9/9/2020

Agenda item II.M

# Historic Area Work Permit

10201 Menlo Ave., Capitol View HD

# Proposed Tree Removal

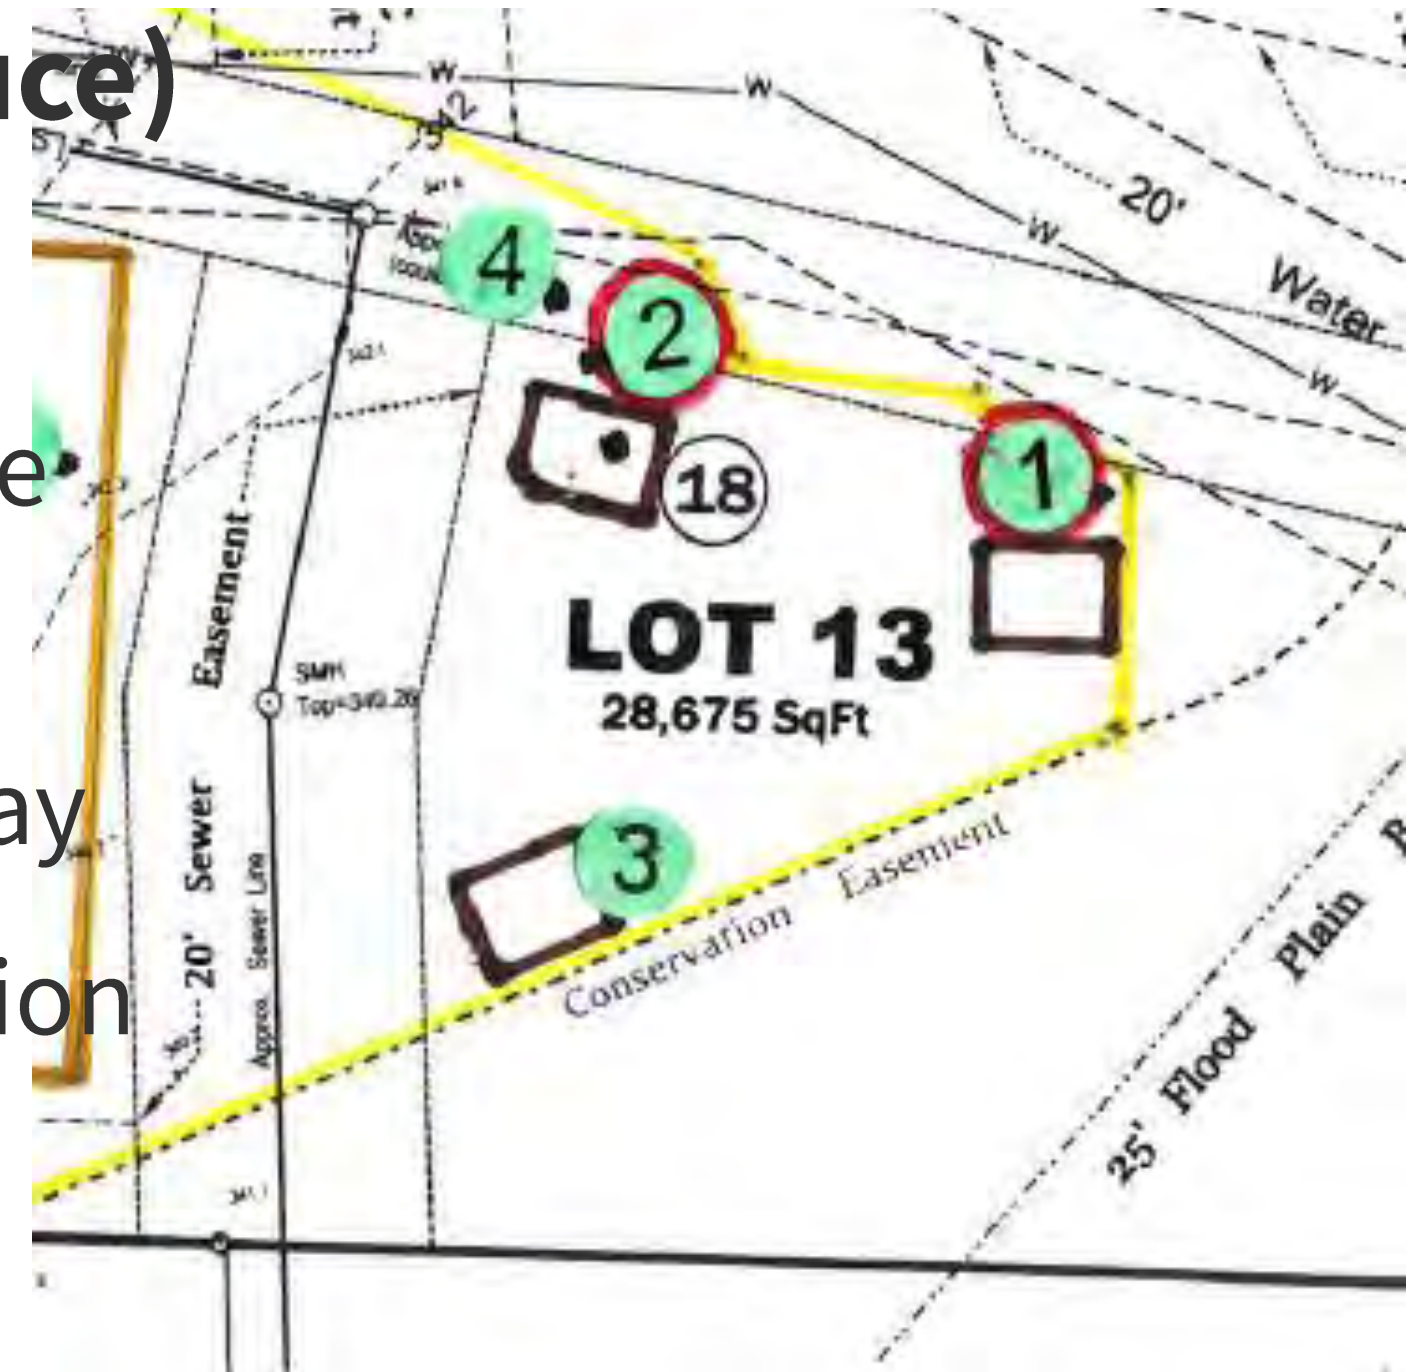
## **Trees 3 (6.25" Tulip Poplar & 4 (10" Spruce)**

- Located in the proposed drywell location
- Drywell relocation would require expanding the limits of disturbance
- Trees are not visible from the public right-of-way
- Tree 4 only has needles at its crown, an indication of poor health.

Trees 8 (9" Maple), 9 (10.5" Black Locust), and 10 (8" Oak) are in the footprint of the approved building.

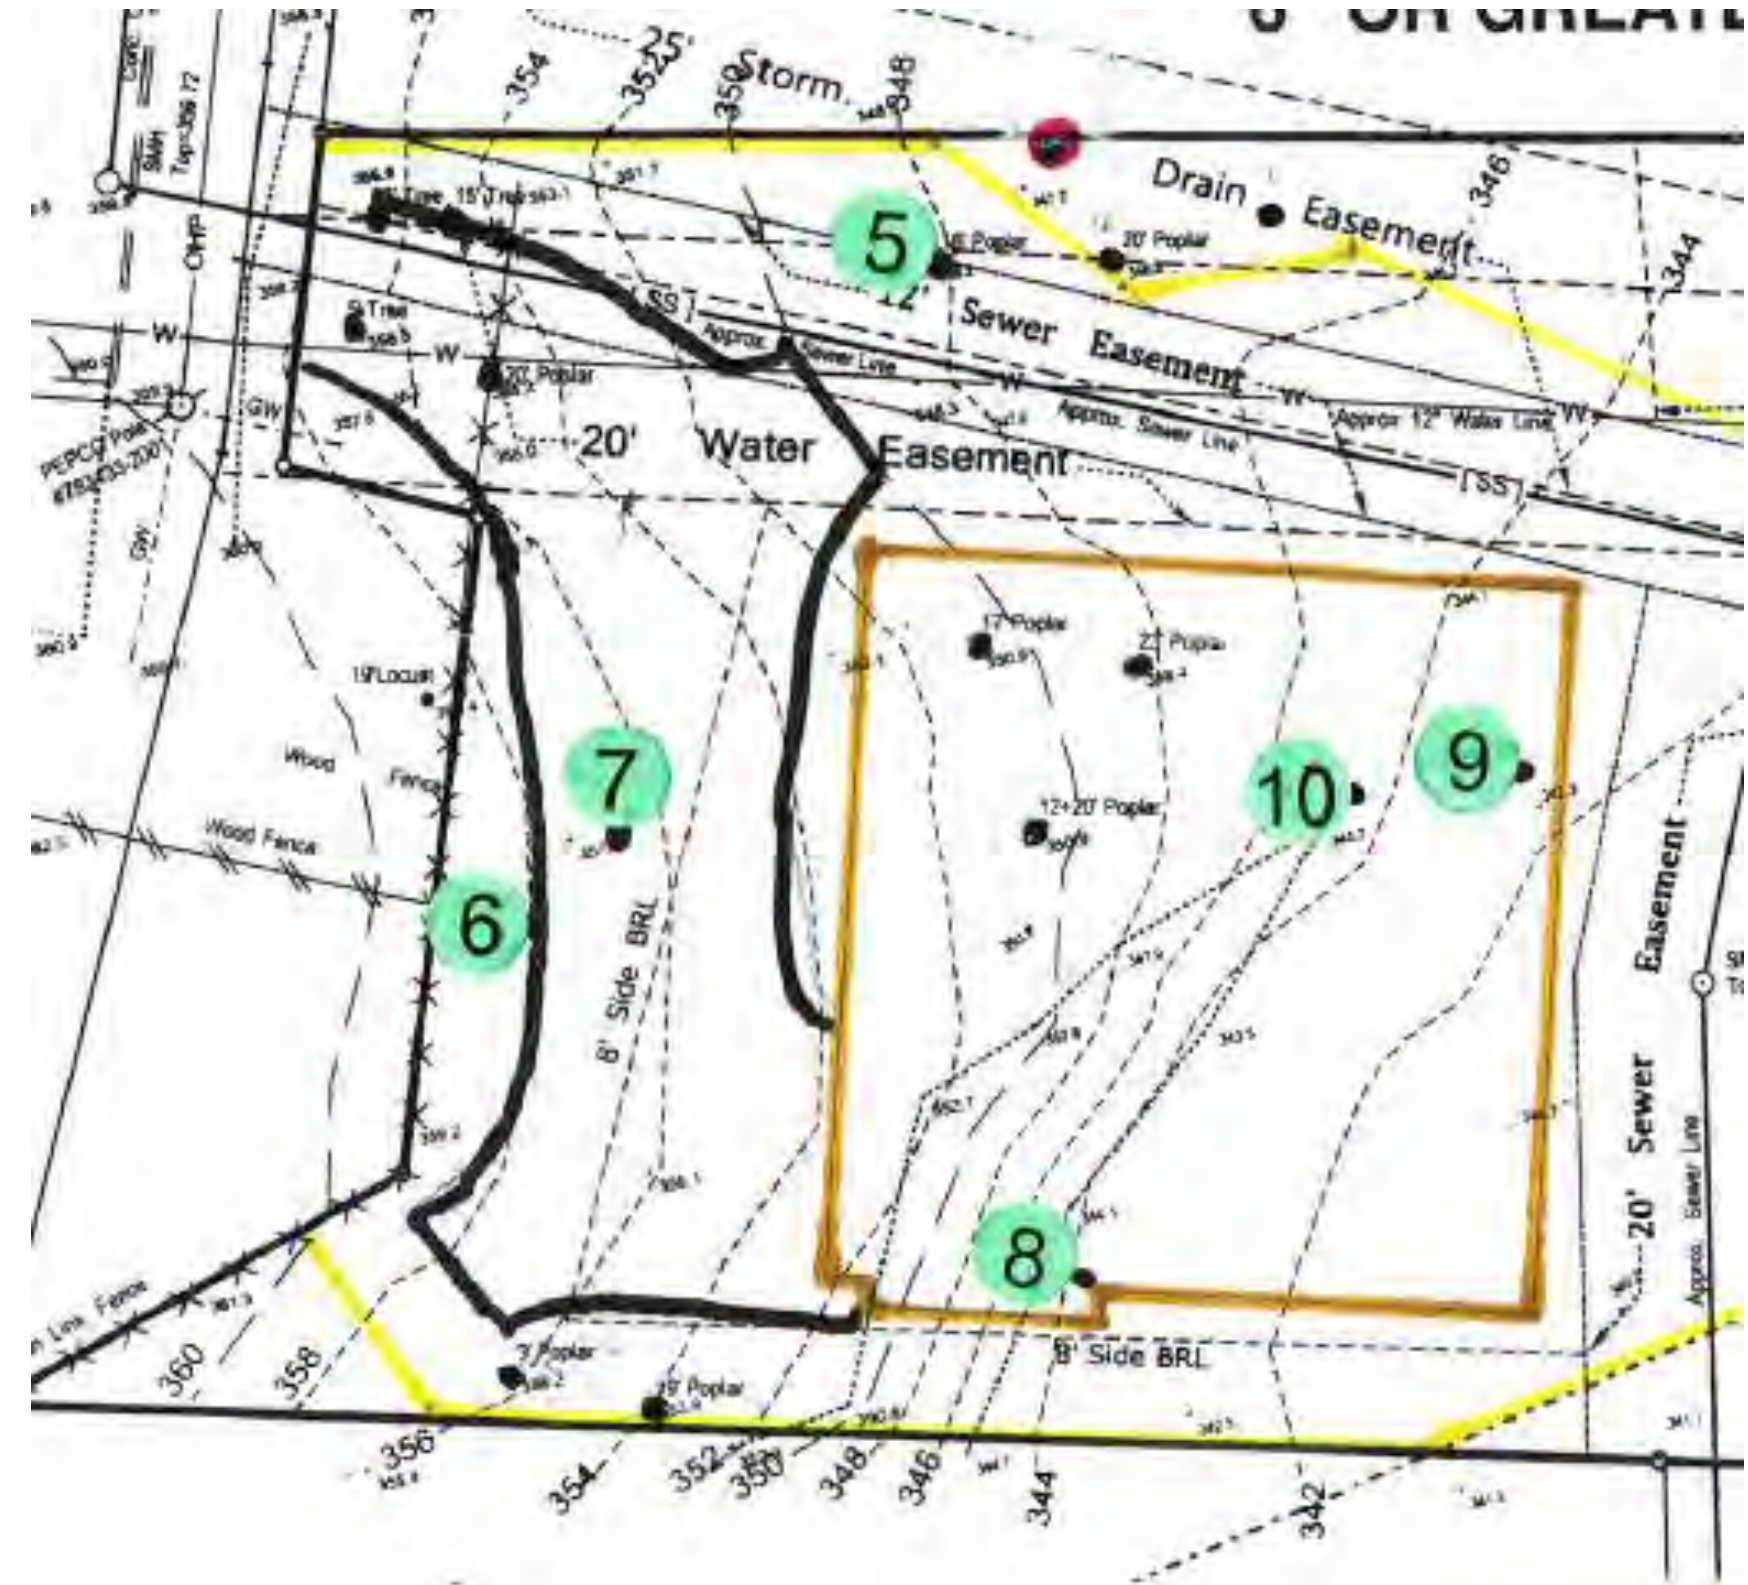
- These three trees are within the footprint of the previously approved house
- Based on the site limitations, there is no other location to place a house on this site
- Denying the removal of these trees would frustrate the purpose of the HAWP and deprive the applicant reasonable use of the property.

Trees 6 (8" Maple) and 7 (7" Maple) are in the footprint of the approved driveway

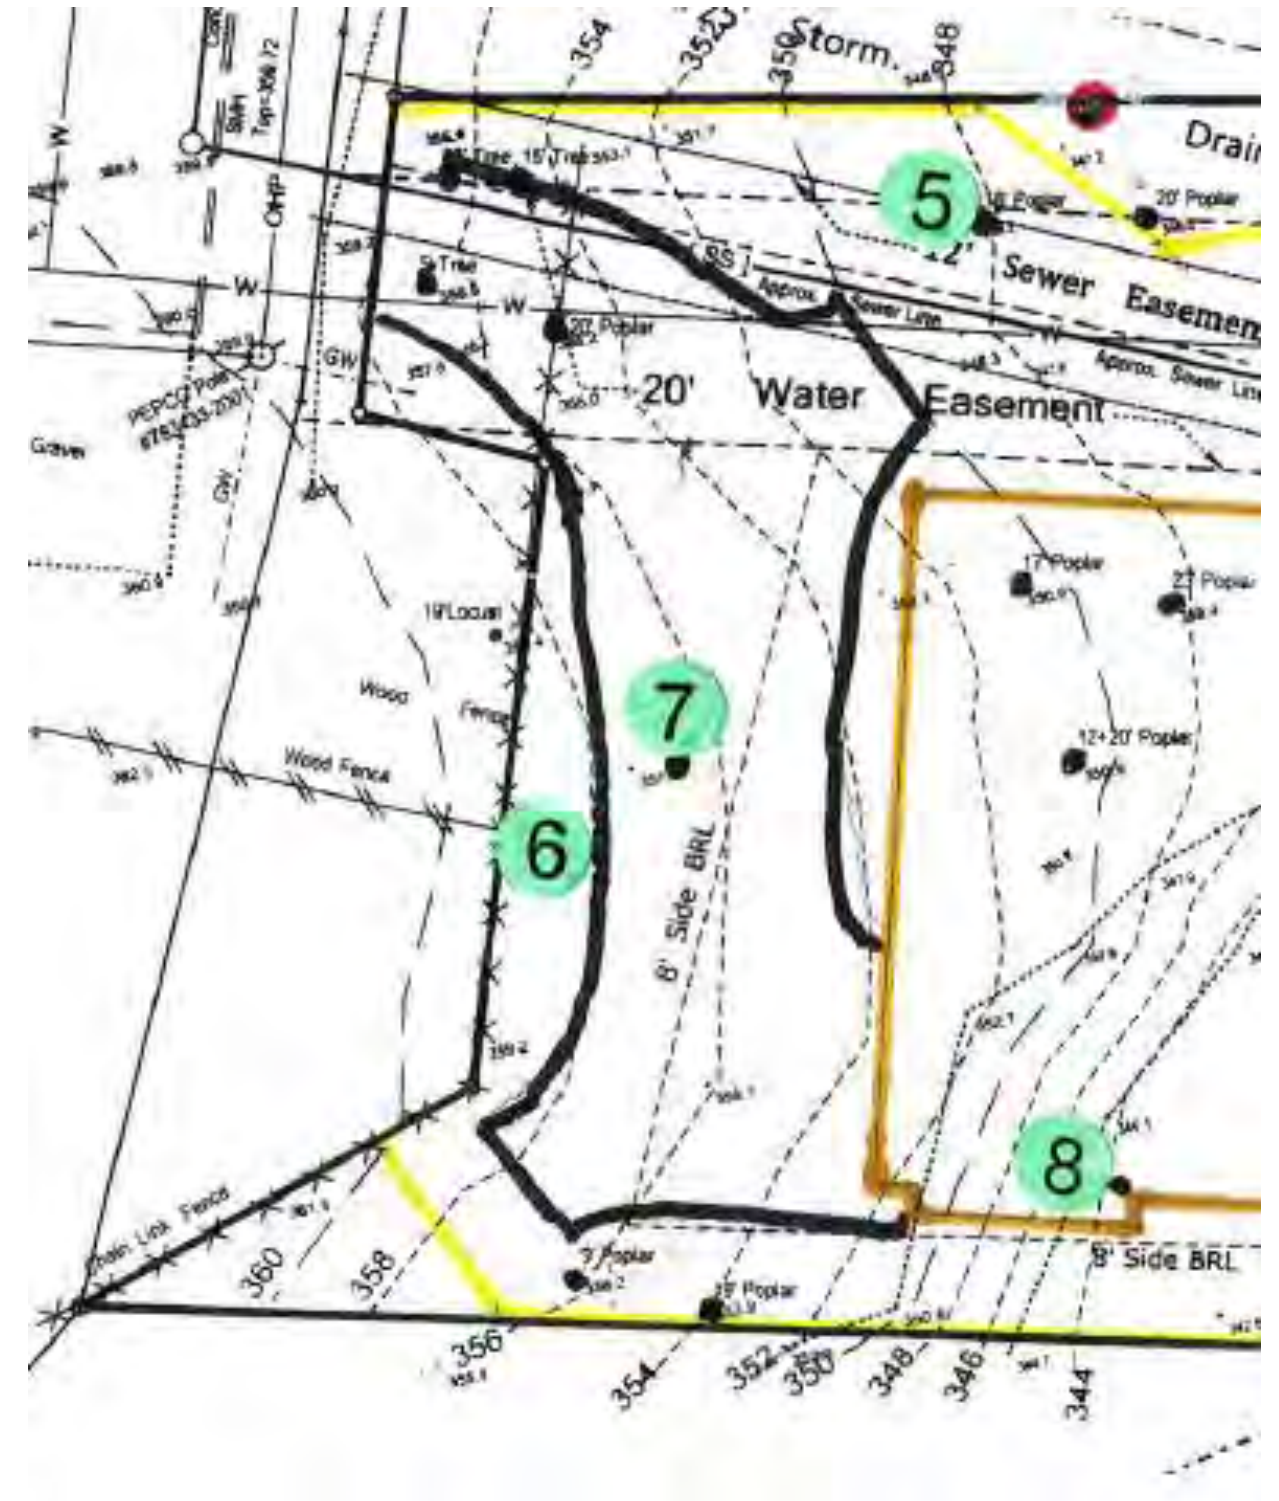
- Both trees are to the south of the right-of-way
- Without these trees, there would be no access to the previously approved one-bay garage
- Denying the removal of these trees would frustrate the purpose of the approved HAWP

Tree 5 (8.5" Tulip Poplar) is adjacent to the driveway and the area around the tree will be re-graded to improve drainage and limit erosion
